Access Compliance Report

Public Rights-of-Way

(Curb Ramps)

Intersection ID: 15397	Main Street: N_WENDOVER_RD	Cross Street: N_WENDOVER_RD_RA	Location:	N
ADA ID: 802A538706B6	Ramp Type: Perp	Initial Pass/Fail: Pass	Overall Compliance: No	Severity Score: 12.5

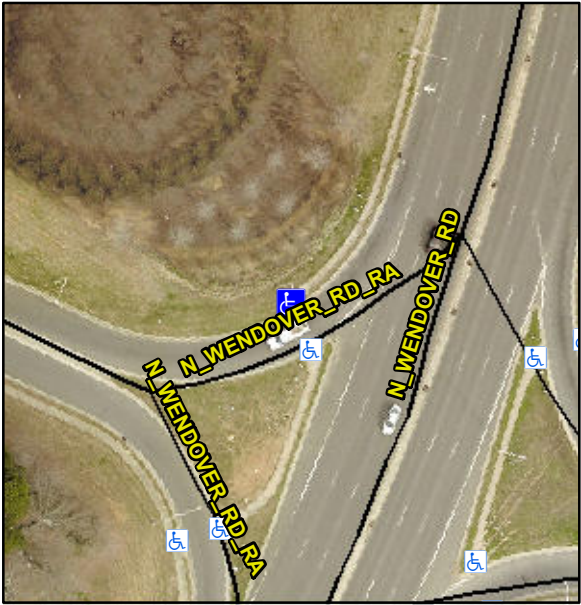
Codes/Mitigation Info/Possible Solution			Field Measurements/Component Compliance		
	Possible Solutions:		Compliance	Description	Data
	Remove & Replace Entire Ramp.		N/A	Ramp Length (in)	81.0
	Remove & Replace Gutter.		Yes	Ramp Width (in)	49.5
			N/A	Flare Type LT	Sloped
			N/A	Flare Slope LT (%)	5.0
			N/A	Flare Traversable LT?	Yes
			No	Landing Length (in)	N/A
			No	Landing Width (in)	N/A
			No	Landing Slope (%)	N/A
			No	Landing X Slope (%)	N/A
Surveyor Notes: N/A PROW/ADA: Not Found, R304.2.1, R304.2.2-Perp, R304.3.2-Para, R304.5.3, R305.1.4, R305.2			N/A	Flare Type RT	N/A
			Yes	Flare Slope RT (%)	7.9
			N/A	Flare Traversable RT?	Yes
			Yes	DWS Provided?	Yes
			Yes	DWS Contrast?	Yes
			Yes	DWS Length (in)	26.0
			No	DWS Full Width?	No
			No	DWS Offset (in)	2.5
			No	Shared Landing?	No
			Yes	Gutter Ponding?	No
Street 1 Name Stop Condition-Street 2 Street 2 Name Stop Condition-Street 1			Yes	Gutter Slope (%)	3.8

No	Gutter X Slope (%)	2.8
			N/A	Painted X Walk1?	N/A
			To SE	X Walk 2 Direction	N/A
			N/A	X Walk 2 Width (in)	N/A
			2.0	X Walk 2 Slope (%)	N/A
			2.5	X Walk 2 X Slope (%)	N/A
			N/A	Ramp inside XWalk1?	N/A
			N/A	Ramp inside XWalk2?	N/A
			N/A	Clear Space?	Yes
Total Cost: \$ 2600.00			N/A	Clear Space to XWalk (in)	N/A
			Yes	Storm Grate/Utility Hazard?	No
				Storm Grate/Utility Type	
			N/A		N/A
			Yes	Surface Condition? (G/P)	Good
